Lot 800 I Retirement Resort - SITE PLAN

PROJECT
Lot 800I Retirement Resort
Lot 800I Baringa Drive
Baringa

PLANS AND DOCUMENTS referred to in the PDA DEVELOPMENT APPROVAL

Approval no: DEV2024/1547

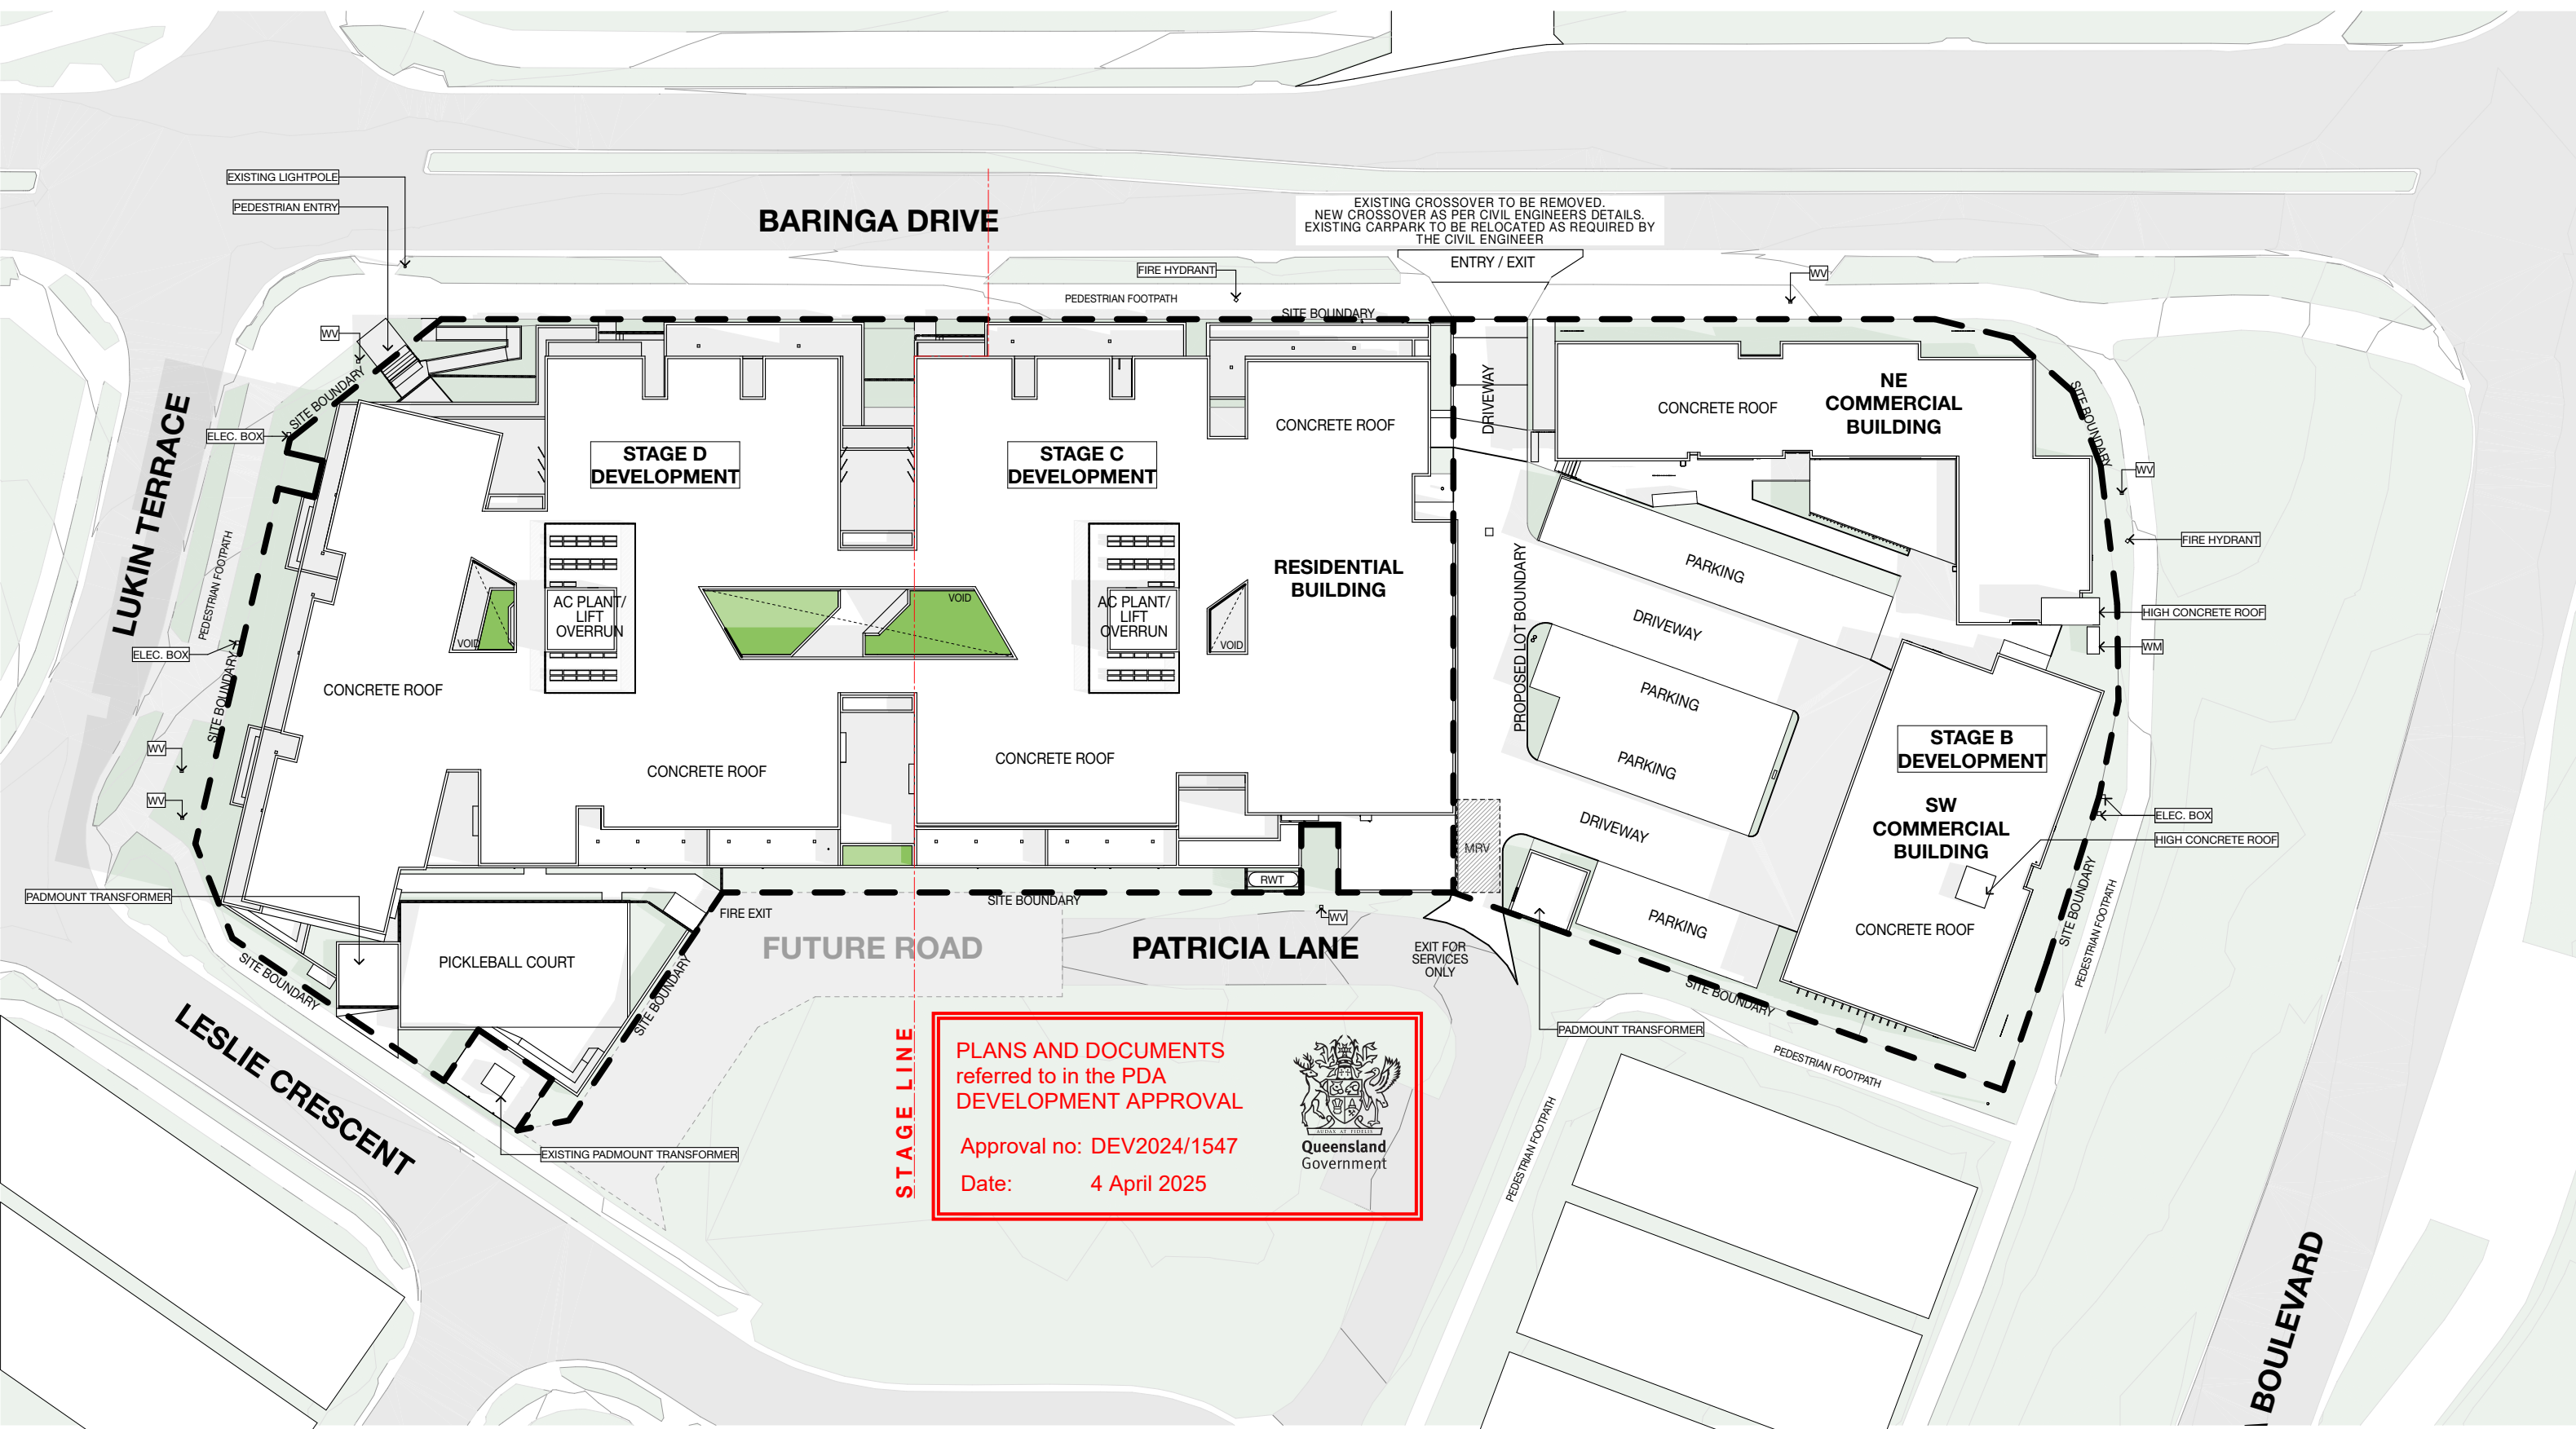
AMENDED IN RED

By: Matthew Buchanan

Date: 7 March 2025

Lot 8001 Retirement Resort - BUILDING MATRIX

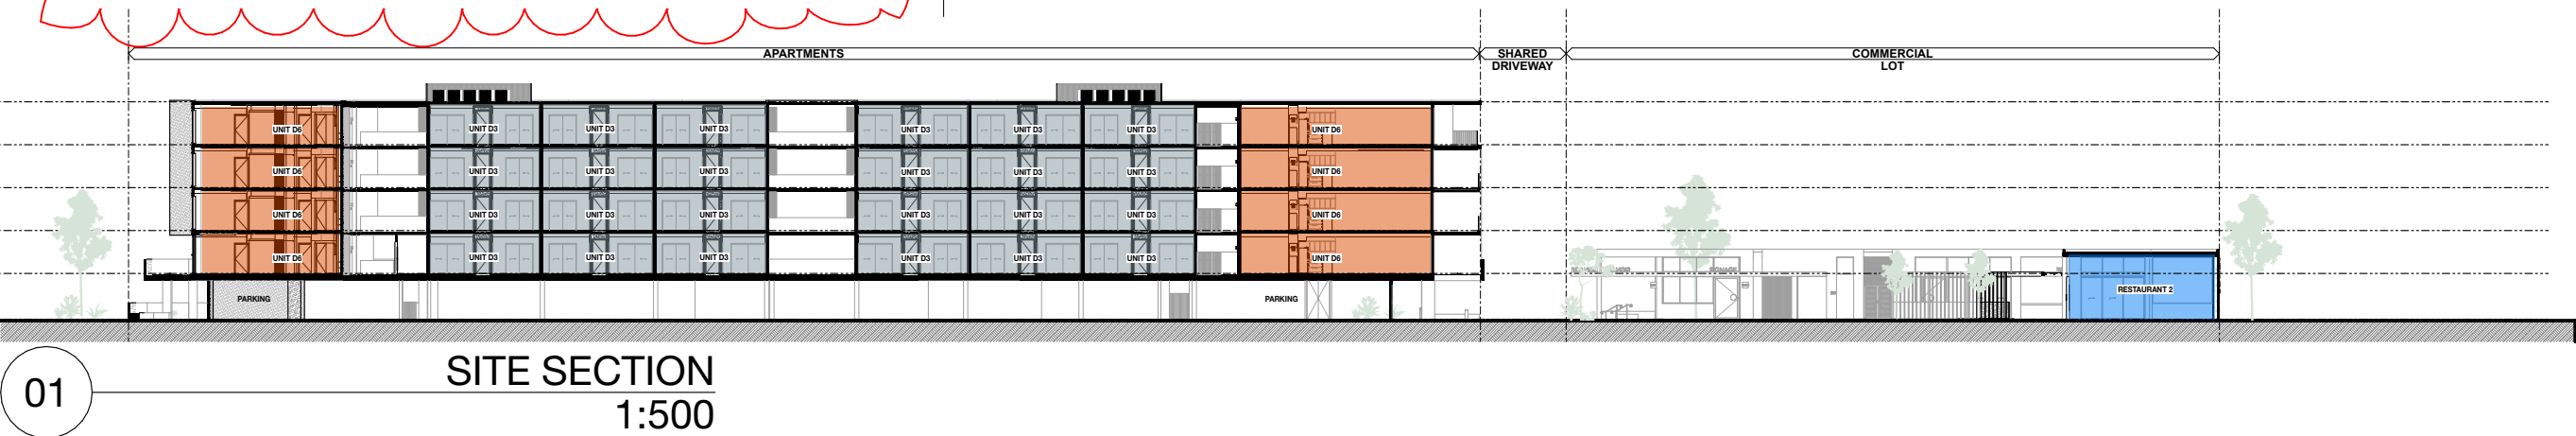
RFI - 1A,1B

RFI - 3

To be provided in accordance with Electric Vehicle Readiness condition

AMENDED IN RED

Lot 8001 Retirement Resort - COMMUNAL AREA CALCULATION

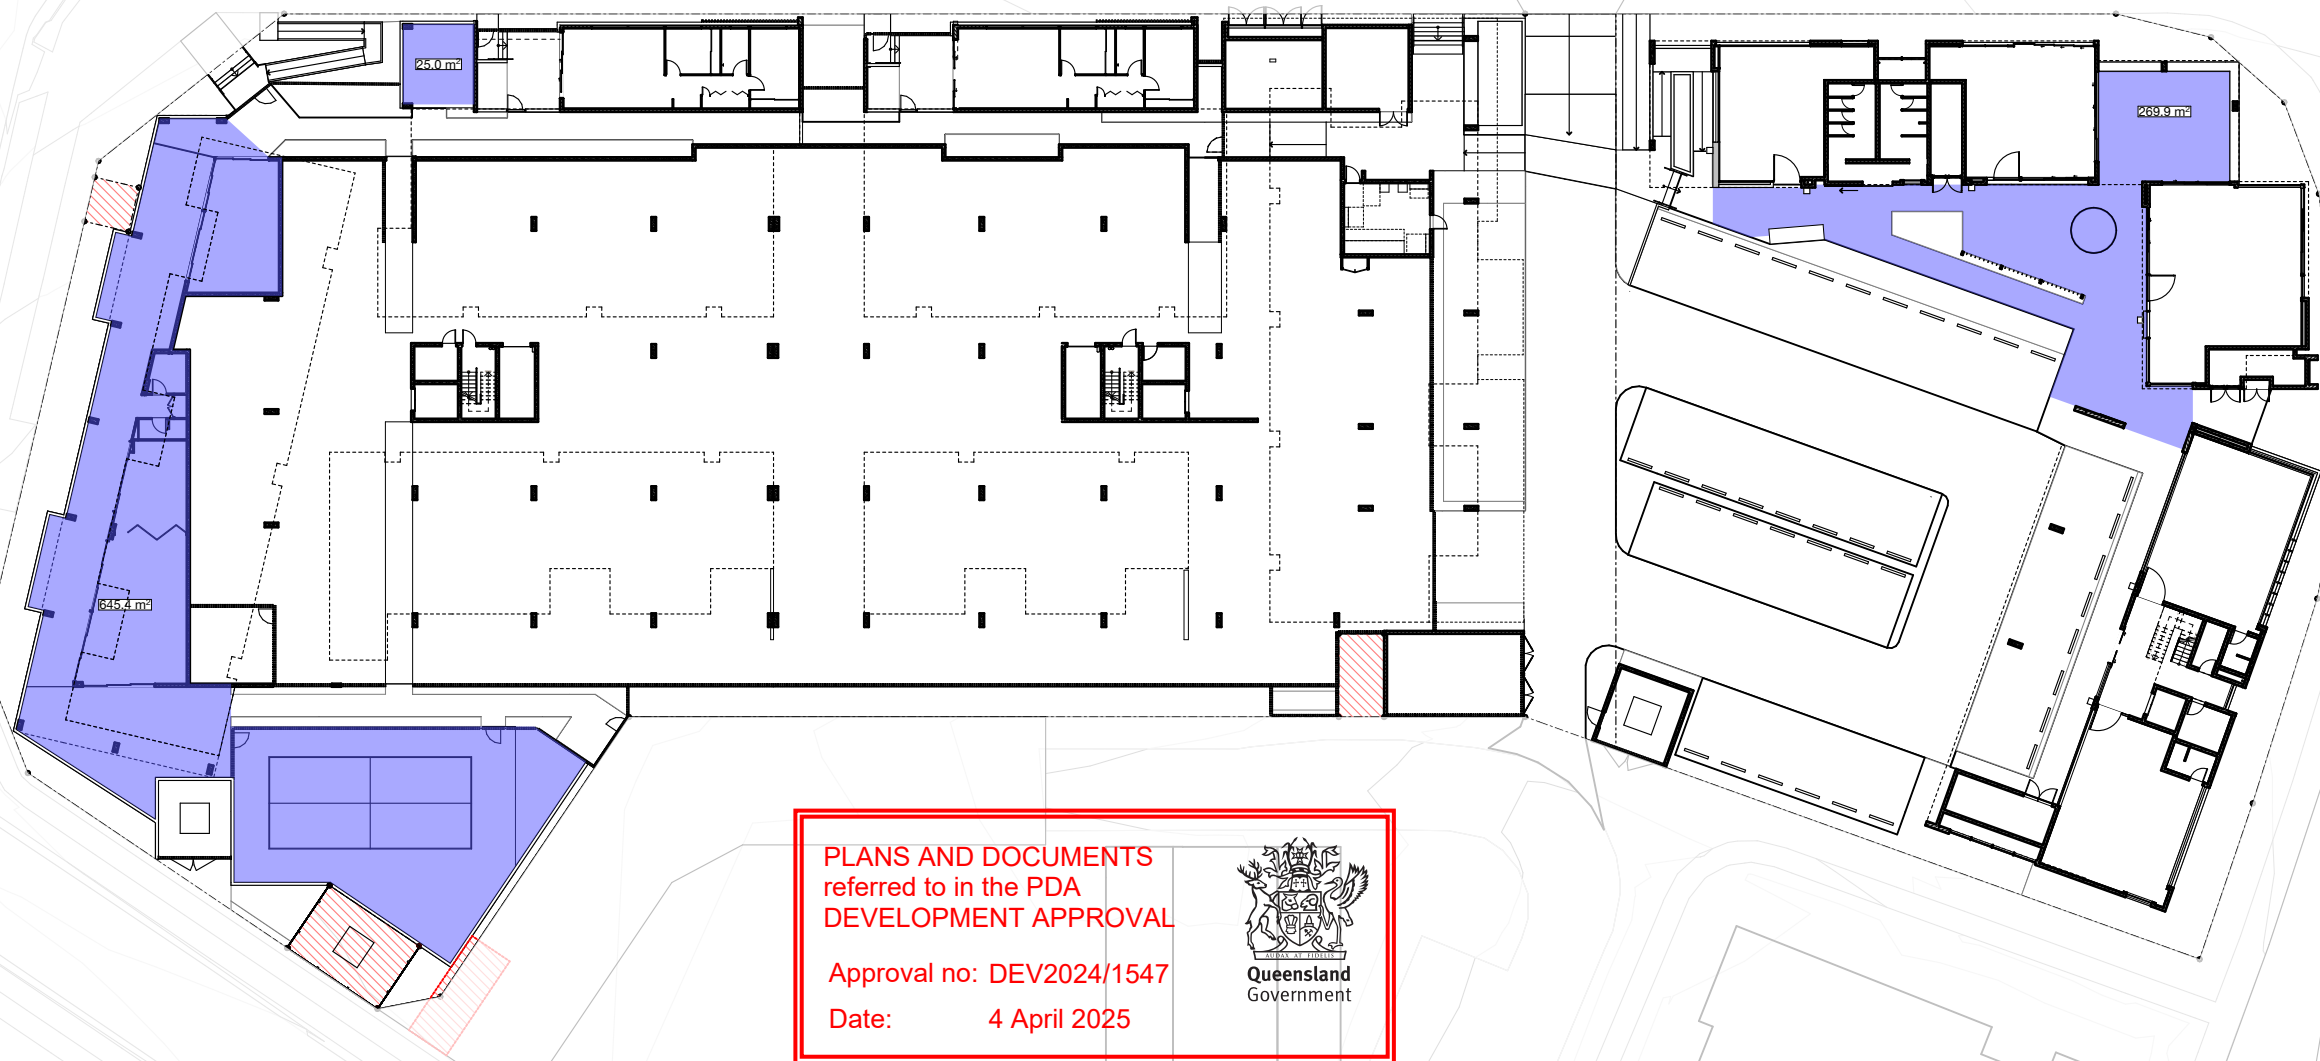
RFI - 1C

RFI CALCULATIONS

Medium and High Rise Buildings Guideline
min 30% of the site area for landscaping and
recreation space.

Proposed Calculations

Residential: 29.5% (1449.69m²)
Commercial: 25.2% (708.4m²)
